VEHICLE RECALL

G-04503
July 2004

SUBJECT: SAFETY RECALL (U.S., EXPORT)
BUNK CONTROL PANEL of certain 9100, 9200, 9300, 9400, and 9900 models built 4/1/1994 thru 6/16/2002

Figure 1

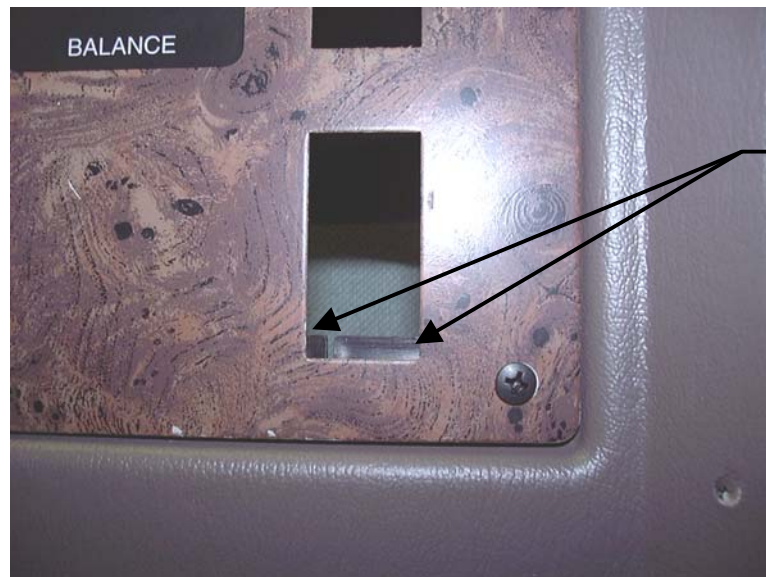
- Water shield flange may interfere with lower switch body

2. Cut a small notch in the flange to clear the bottom of the switch.

Figure 5

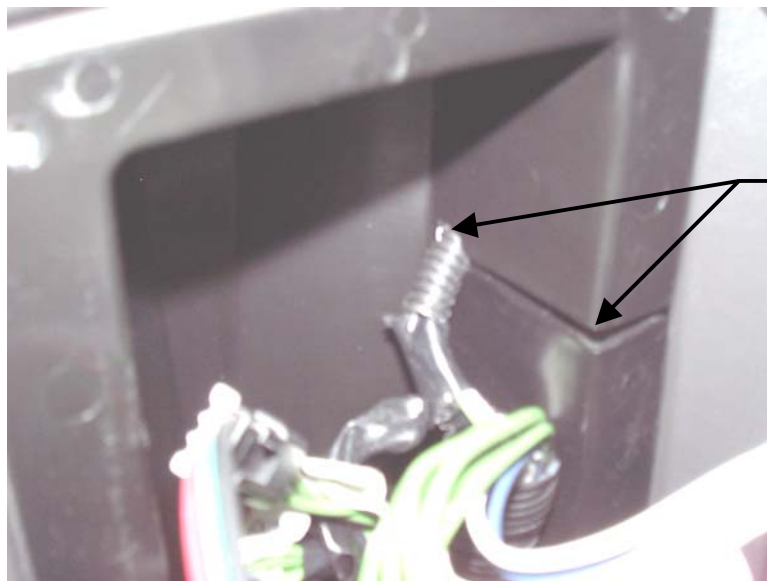
5. Install water shield into opening.
6. The main electrical harness must pass through the bottom opening of the water shield and the dome light breakout must pass through the slit and hole in the side of the shield.

NOTE: *Ensure dome light conduit is locked in place in hole in side of part. If conduit will not lock into place, use of electrical tape may be required to ensure wire chafing does not occur.*

- Slit in side of panel is for **dome light** breakout to pass thru.
- Ensure conduit passes thru hole and is locked in place.

Figure 6

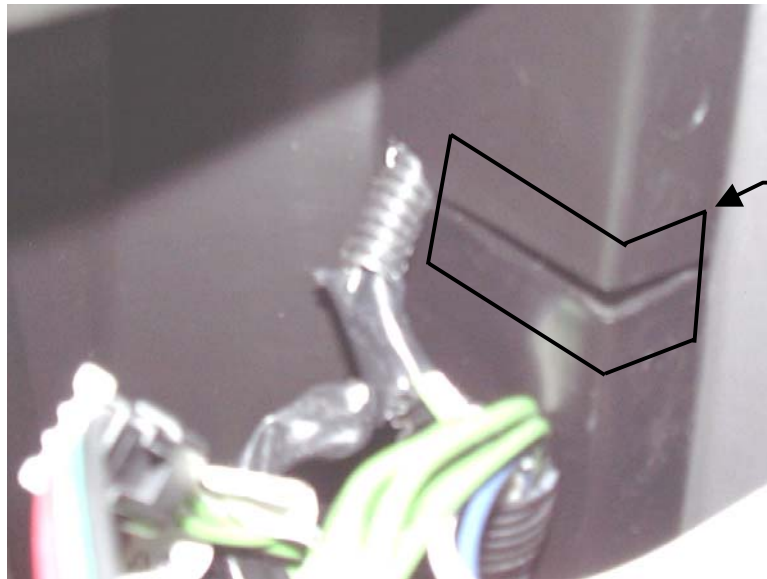
7. Install a piece of duct sealing tape (or equivalent) as indicated below. Ensure tape covers entire slit.

- Tape should not extend past flange.
- Tape should not be visible when control panel is re-installed.
